City of Oregon City

Meeting Agenda - Final Planning Commission

FILE NO.: CP 12-01: Master Plan and DP 12-01: Detailed Development Plan

REQUEST: The applicant submitted a Concept (General) Development Plan and Detailed Development Plan to incorporate the Silver Oak building at 1810 Red Soils Court into the Red Soils Master Plan, change the use of the building from light industrial to storage and office use and construct a fence and install landscaping onsite. In addition, the applicant proposed to obtain adjustments to development standards for fence height and building material.

Oregon City Municipal Code Adjustment #1: Fence Height

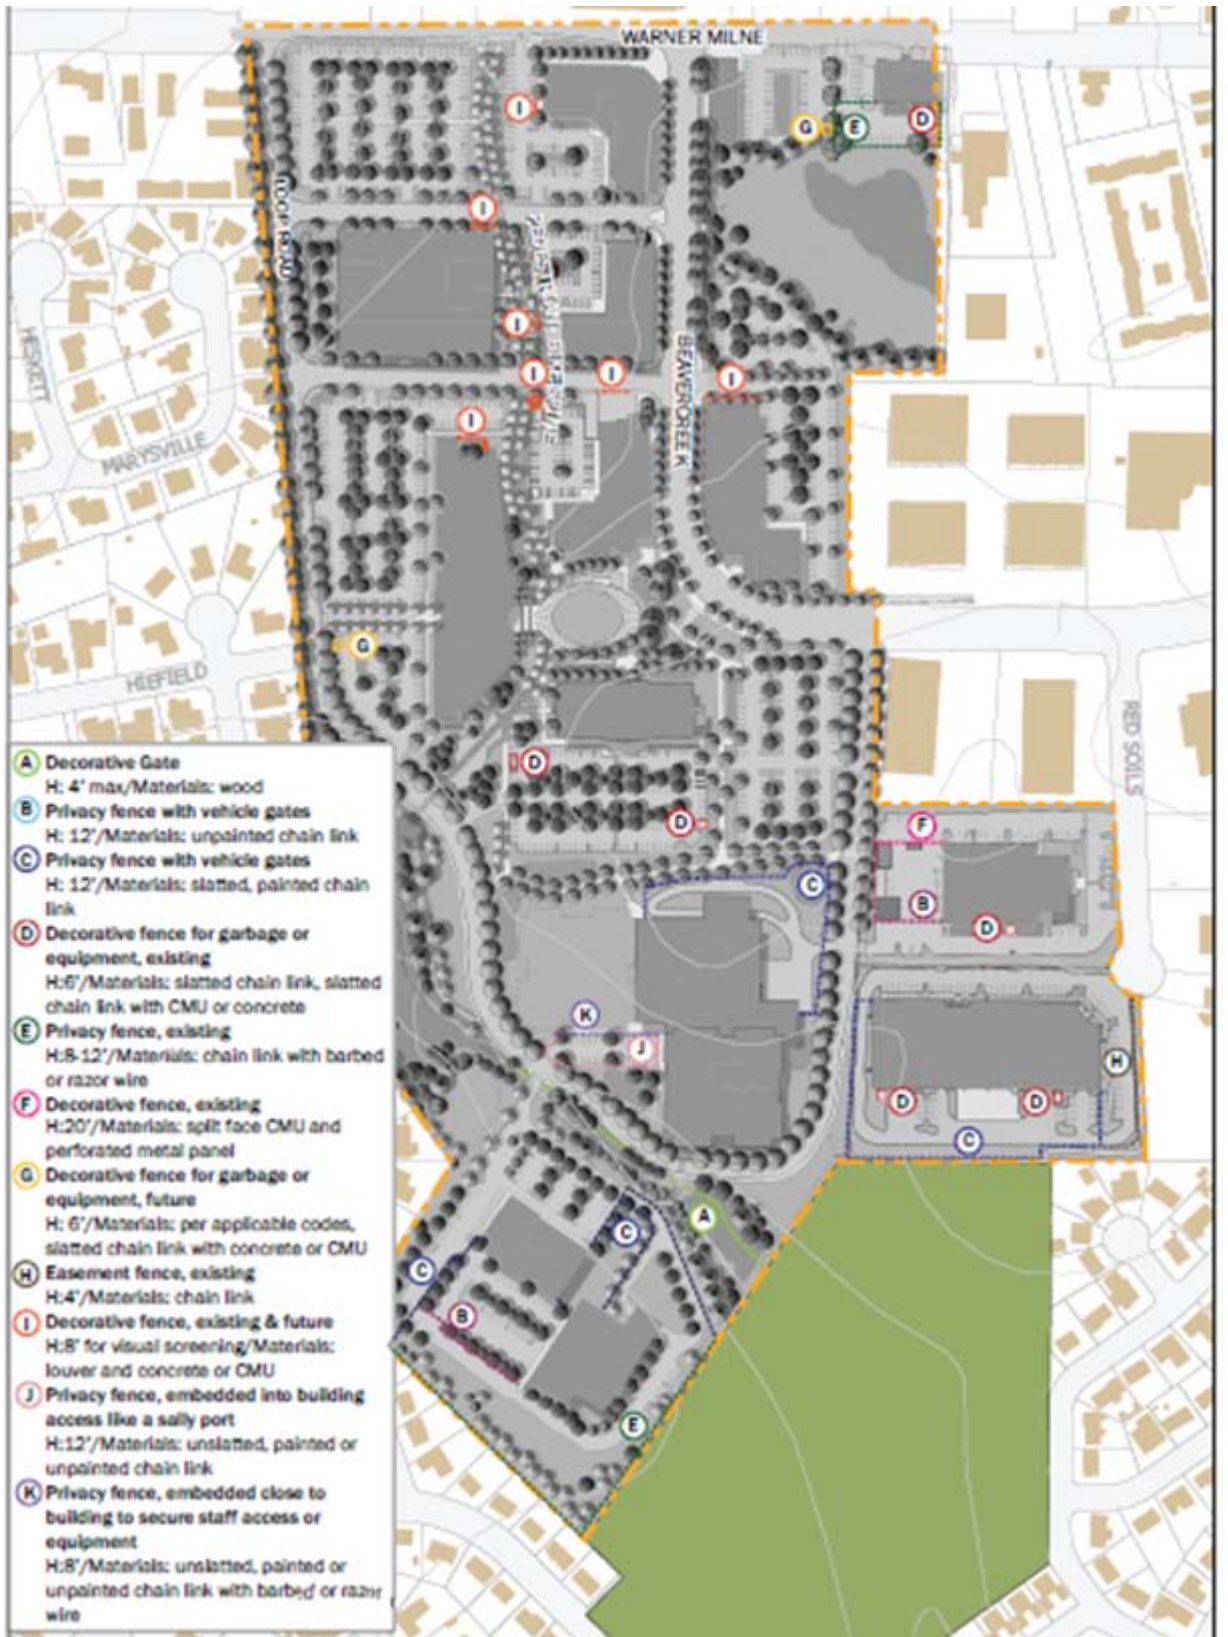
The existing fence code was adopted within the past few years, before a majority of the fencing onsite was constructed. The applicant requested an adjustment to this requirement which would allow a variety of fence heights as identified on pages 61-63 of the Master Plan (provided below).

Finding: Complies with Condition. The purpose of limiting fence height is to provide a visual connection between development and the street, enhancing Oregon City through the creation of attractively designed streetscapes, improving public safety by providing "eyes on the street" and promoting community interaction. The applicant indicated that "providing a safe environment for public and staff safety is the most important consideration for the County." In addition the county stated there is a vast array of threats and Clackamas County must incorporate recommendations from the Department of Homeland Security, State and local law enforcement agencies, such as construction of fences around the law enforcement facilities.

As a whole, the adjustments would allow new fencing throughout the subject site which limits connections between the buildings and the street by installing large barriers of a lesser quality of design which are visible to the public. Approval of all of the adjustments would allow future development to be inconsistent with the current Oregon City Municipal Code and the approved Master Plan.

- The Planning Commission waives the fence height requirement for all existing fences. Existing fences may be replaced with the same height fence.
- Installation of new fences in the front and living room portion of the site shall comply with the Oregon City Municipal Code.
- The height of future fences in the back room portion of the site shall be limited to that proposed on page 63 of the Master Plan (shown above).

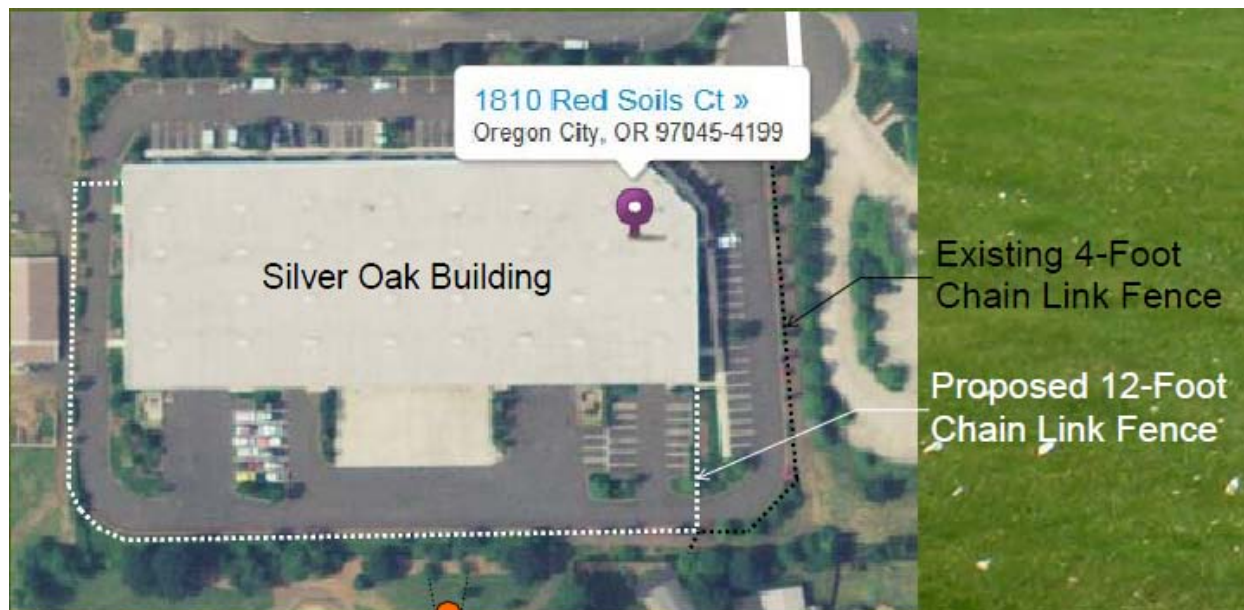
Finding: See the analysis within this report approving this request. The applicant proposed to install a 12 foot tall chain link fence around a portion of the parking lot at the Silver Oak Building in the rear portion of the Red Soils Campus (Exhibit 12, shown below). The fence would provide privacy screening and security for the Sheriff's evidentiary material and fleet vehicles. Please refer to the analysis in Chapter 17.65.070 for the requests to adjust the fence height and material standards.
